DATE: September 26, 2007

SUBJECT: **Proposed Major Amendment 2-07** to the UCSB Certified Long Range Development Plan (LRDP); and **Notices of Impending Development (NOID) 5-07 and 6-07**, for the Harder Stadium Storage and Engineering II Addition projects, for Public Hearing and Commission Action at the October 10, 2007, Commission Meeting in San Pedro.

ADDENDUM

Exhibit 5a

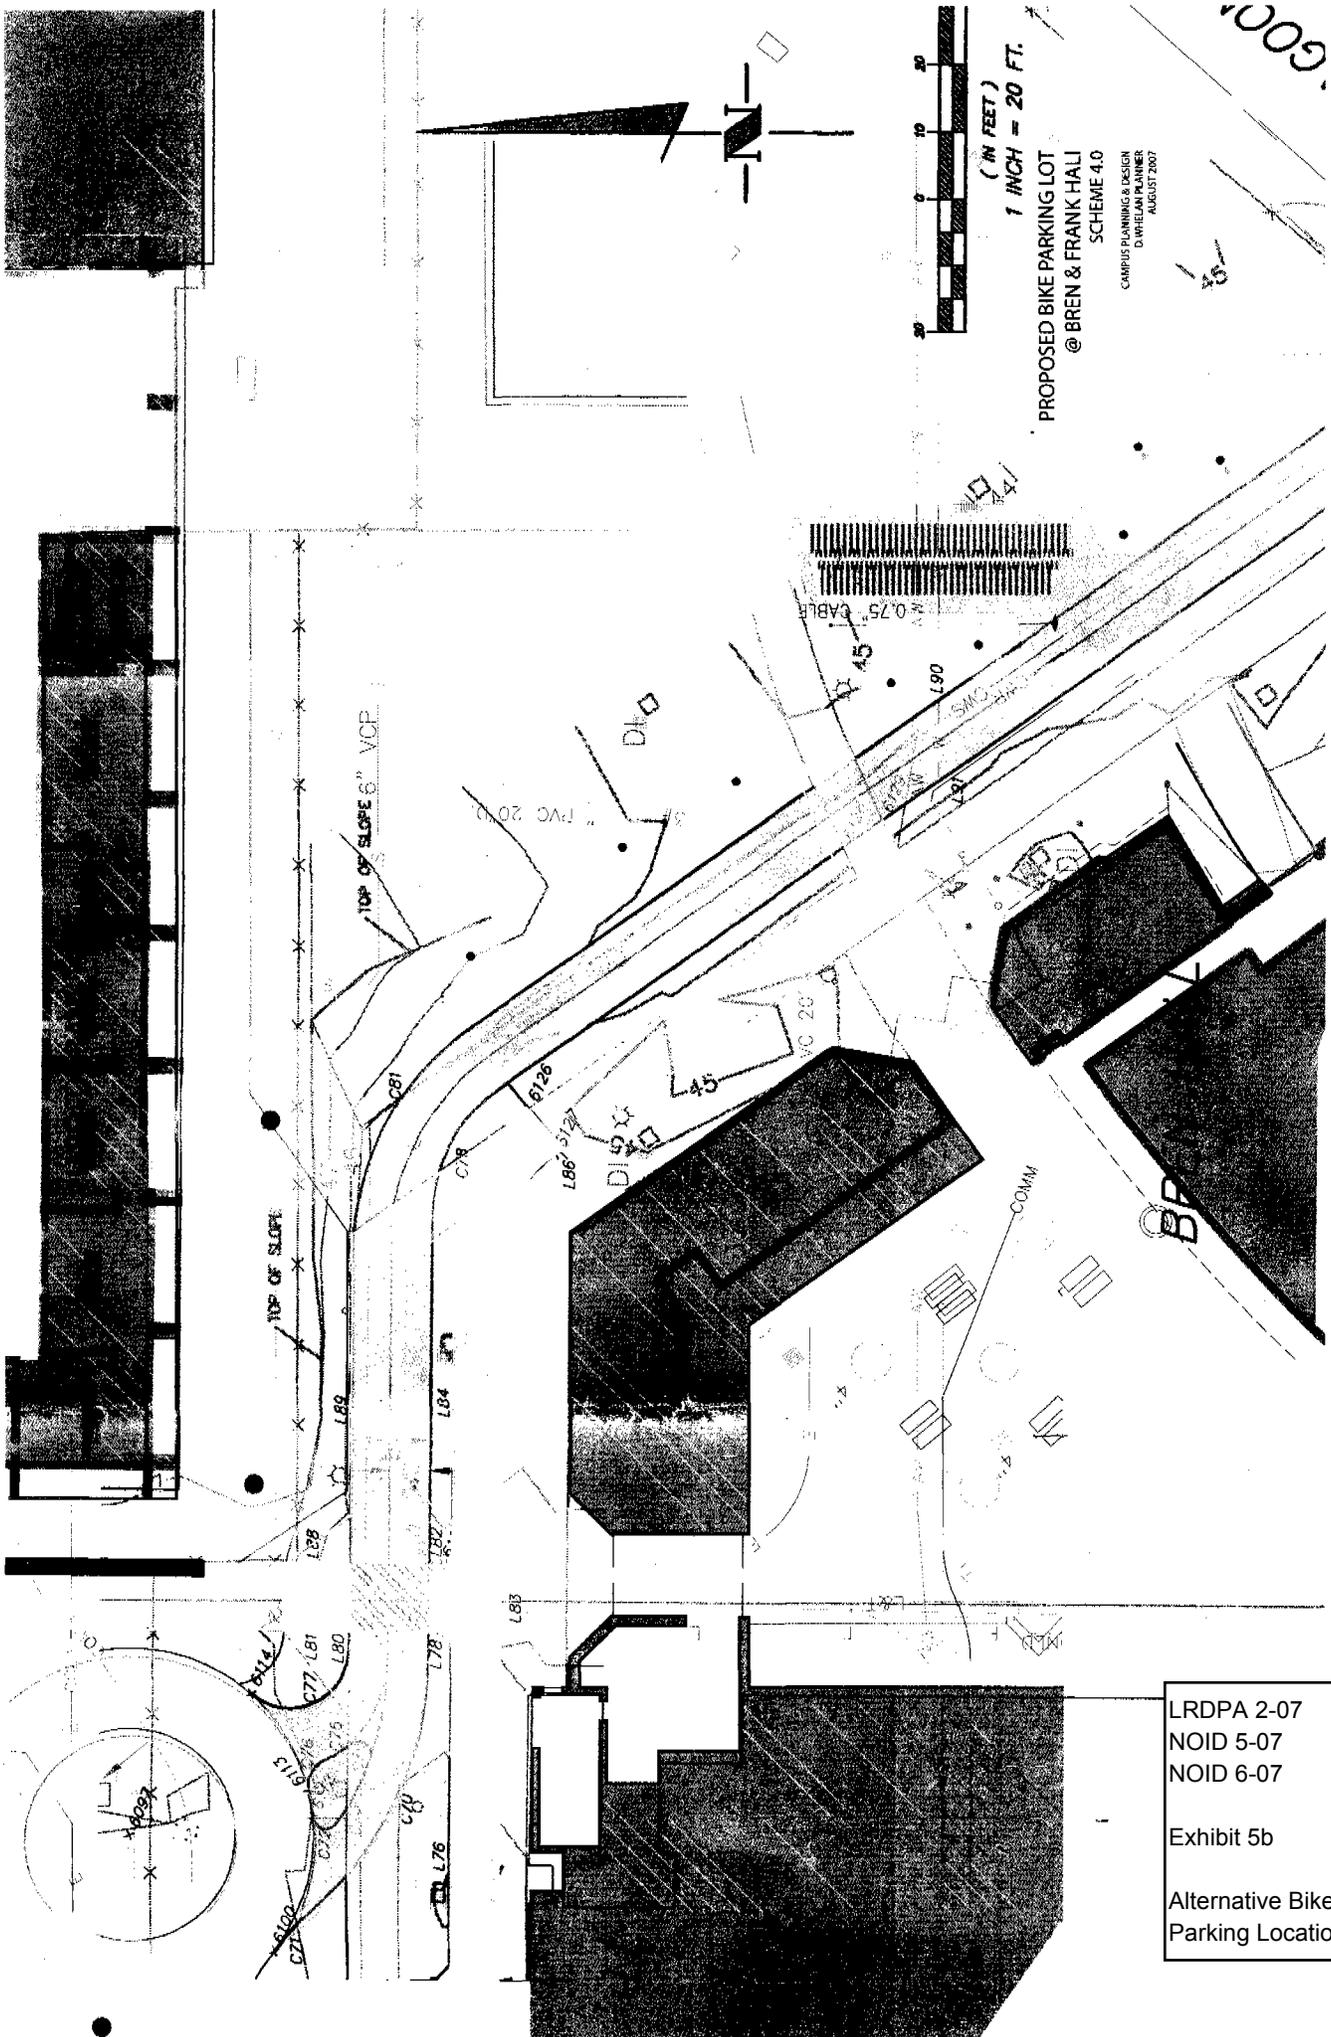
- a. The bicycle path on the “Engineering II Addition Project Site” shall be rerouted as shown on Exhibit 4d.
- b. The existing bicycle parking facilities on the “Engineering II Addition Project Site” shall be relocated as shown on Exhibit 4d.
- c. The new/relocated bicycle parking facilities shall provide for a minimum of 120 new/replacement bicycle parking spaces. New/replacement bicycle parking facilities may be located in one, or a combination of, the following areas:
 - i. The area adjacent to the west entrance to the proposed Engineering II Addition as generally shown in Exhibit 5a;
 - ii. The area adjacent to the pathway and proposed bikeway between the Bren School and Engineering I buildings as generally shown in Exhibit 5c; and/or

- i. Adjacent to the west entrance to the proposed Engineering II Addition as generally shown in Exhibit 5a;
- ii. Adjacent to the pathway and proposed bikeway between the Bren School and Engineering I buildings as generally shown in Exhibit 5c; and/or
- iii. South of the Engineering I sidewalk and east of the Bren Lecture Halls as generally shown in Exhibit 5b.

Prior to the commencement of development of the Engineering II Addition Project, the University shall submit final plans, for review and approval by the Executive Director, for the replacement of at least 120 bicycle parking spaces at one or a combination of the following locations:

LRDPA 2-07
 NOID 5-07
 NOID 6-07
 Exhibit 5b
 Alternative Bike
 Parking Location 2a

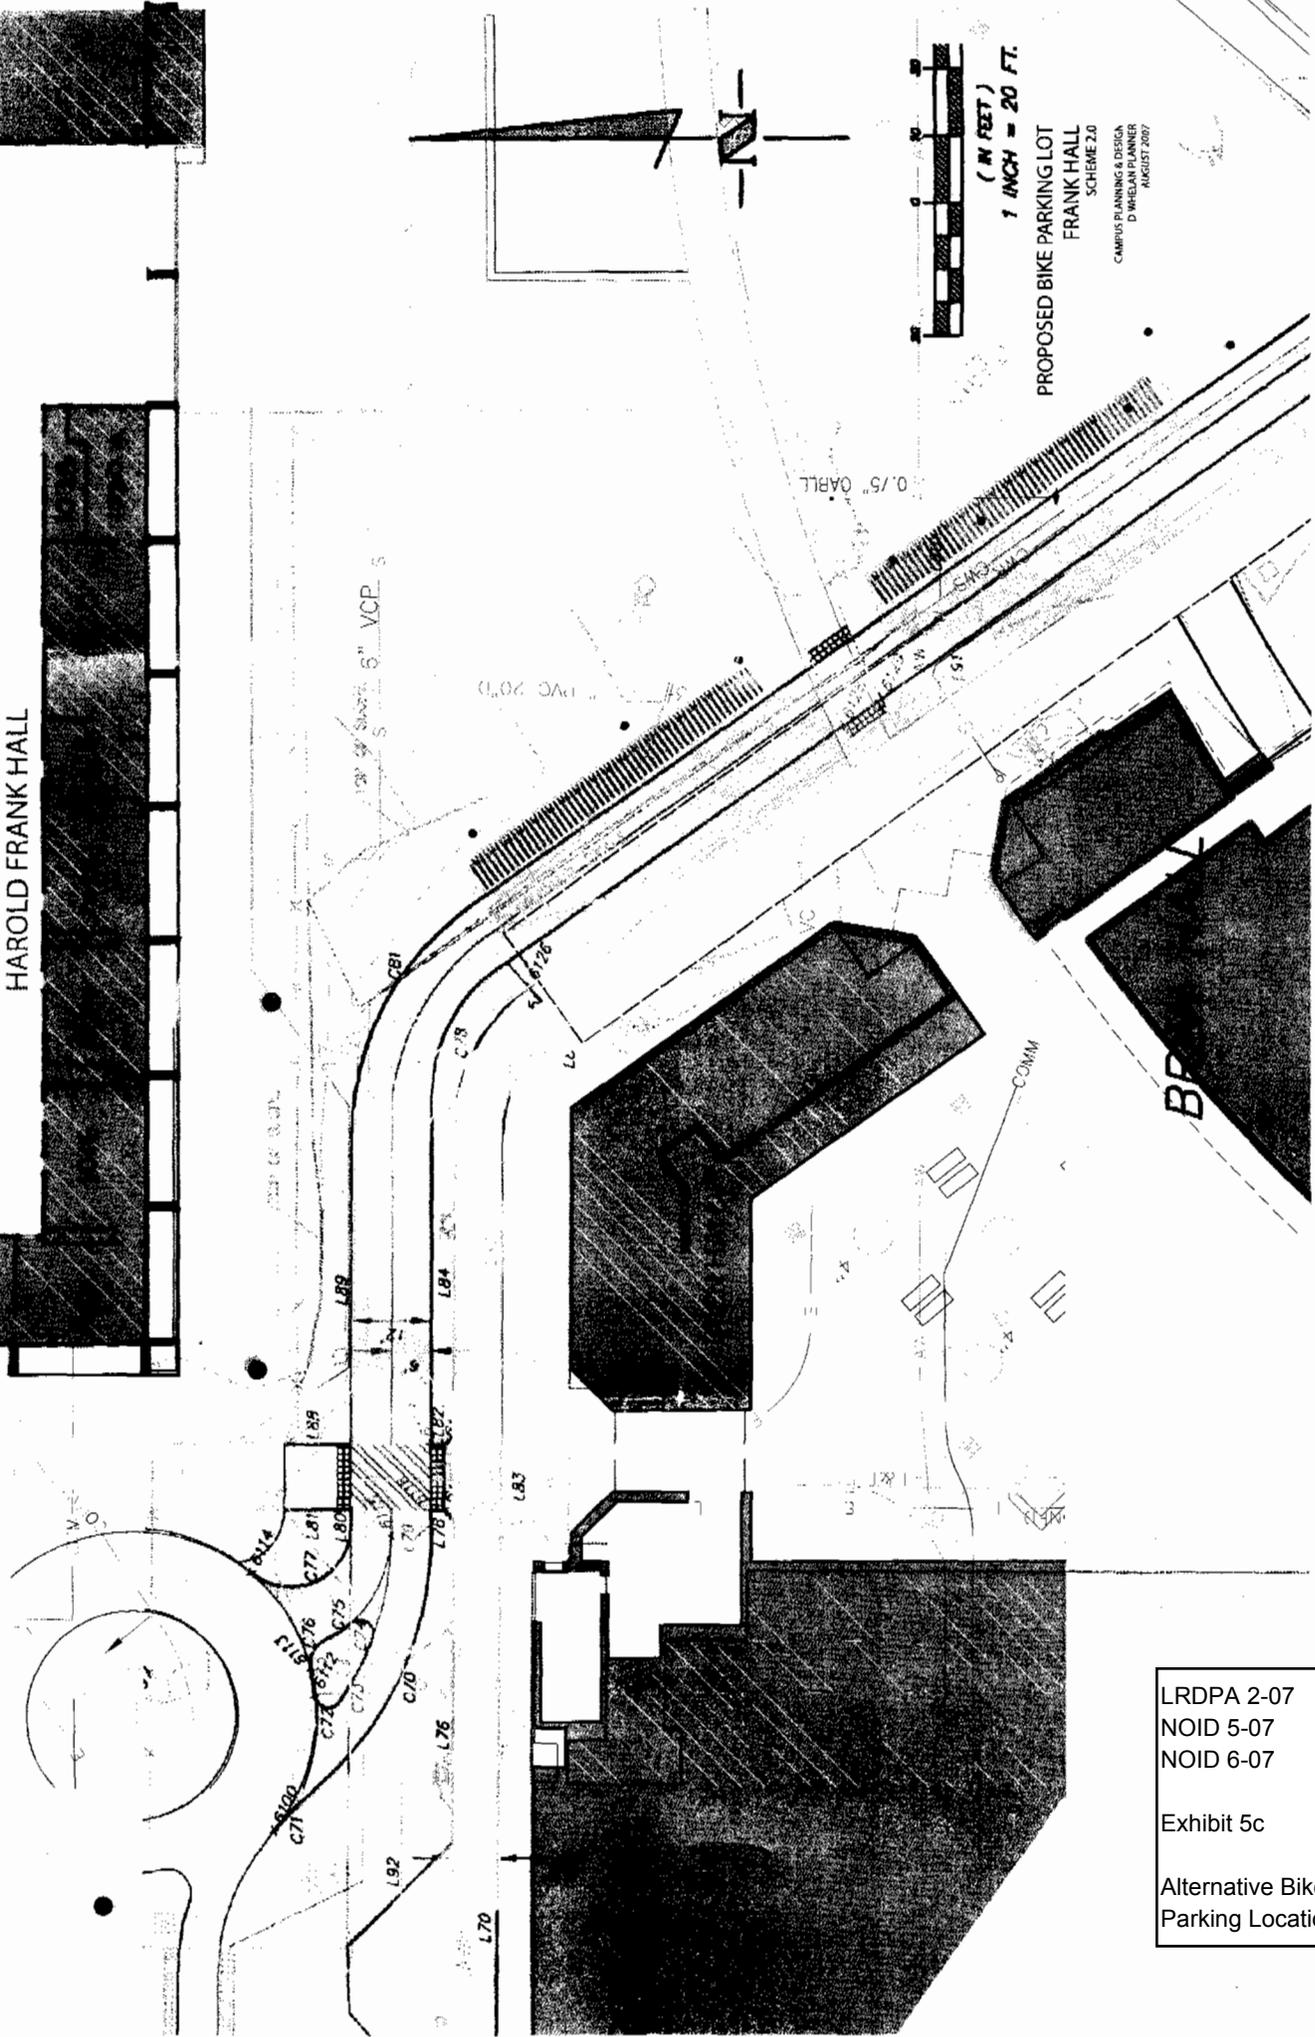
- iii. The area south of the Engineering I sidewalk and east of the Bren Lecture Halls as generally shown in Exhibit 5b.
